Subject: WHITE POWDERY DUST ON INNER SURFACE OF HEADLIGHT LENS	Bulletin No.: 09-007/22
	Last Issued : 03/01/2022

2018 (US spec) / 2019 (Mexico spec)-2021 Mazda6 with VINS lower than JM1GL*****617811 (produced before July 22, 2021)

Detail A

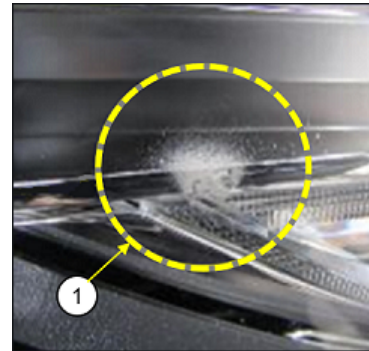
Some vehicles may exhibit a white powdery dust (1) adhering to the inner surface of the headlight lens causing a poor appearance.

This is caused by the edge of the lens support part interfering with the inner lens of the headlight under a strong vibration during driving, scratching the inside of the inner lens. As a result, the resin powder adheres to the inside of the headlight lens. To eliminate this concern, the support rib location of the inner lens has been changed to prevent the interference. Customers having this concern should have their vehicle repaired using the following repair procedure.

1. Verify the customer concern (as shown in the figure in the DESCRIPTION).
2. Replace the front combination light on the defective side(s) with a modified one(s) according to the workshop manual (FRONT COMBINATION LIGHT REMOVAL/INSTALLATION).
3. Verify the repair.
